MIL-C-50652/2 (AR)
AMENDMENT 2
30 April 1982
SUPERSEDING
AMENDMENT 1
3 September 1975

MILITARY SPECIFICATION

CIRCUIT CARD ASSEMBLY: 10548007
(GENERATOR, COMPUTER TIMING)

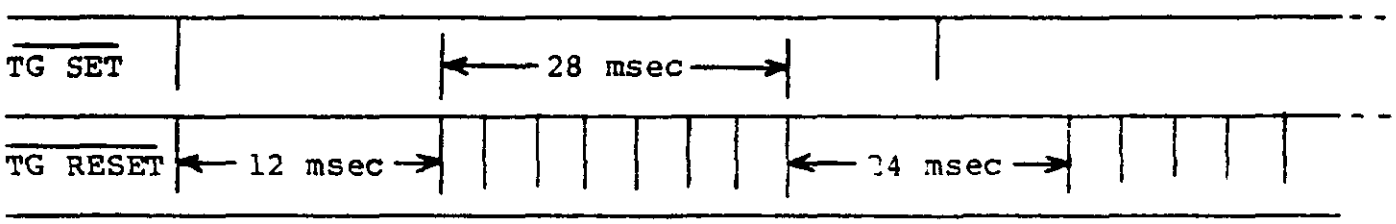
* Delete "$\overline{\text{TG RESET}}$" and substitute new "$\overline{\text{TG RESET}}$"
